TROON NORTH TRACT V

REQUEST FOR STORMWATER STORAGE WAIVER

CITY OF SCOTTSDALE TRACKING NO: 878-PA-2015

Comments on Grading and Drainage (Cycle #2)
LOT V ON THE GREEN
(City of Scottsdale Plan Check Number: 10-PP-2015)

Figure 6-11 Cross Section Locations at a Bridge or Culvert

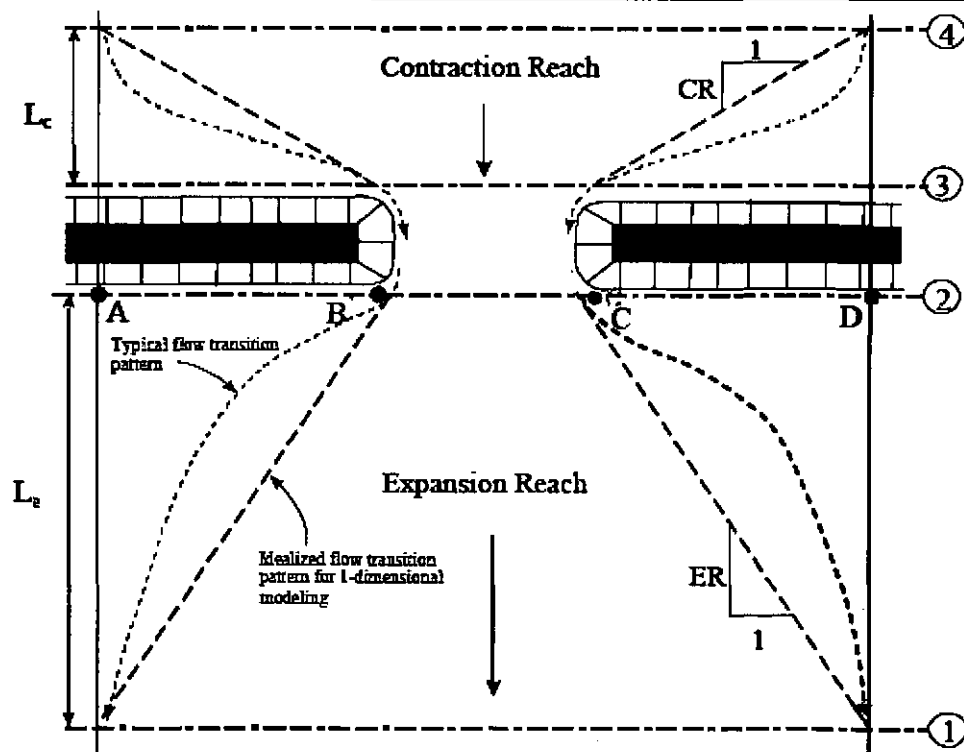
8. Both culvert crossings must be modeled in HEC-RAS using four inter-related cross-sections to accurately simulate flow contraction and flow expansion as outlined in the HEC-RAS User's Manual (please see the below screenshot from the HEC-RAS Manual). [Reference: COS DS&PM: Section 4-1.800]

9. The two cross-sections in HEC-RAS which define the internal sections for the simulation of culvert hydraulics (Section 2 & Section 3 in the above figure in Comment #8), must be laid out along the bottom of the roadway embankment to correctly represent the wash cross-sections. They mustn't be laid out along the pavement or shoulder line of the roadway as appears to be. Please verify.
[Reference: COS DS&PM: Section 4-1.800 & Section 4-1A]
10. Please show the approximate location of the proposed D.E. on all relevant 24"X36" exhibits as well as on the 24"X36" Preliminary Plat which should completely cover the proposed condition base floodplain. If the proposed condition base floodplain spreads over a lot or two which are being proposed to be created, the proposed D.E. must also follow to encompass that.
[Reference: COS DS&PM: Section 4-1.700 & Section 4-1B]
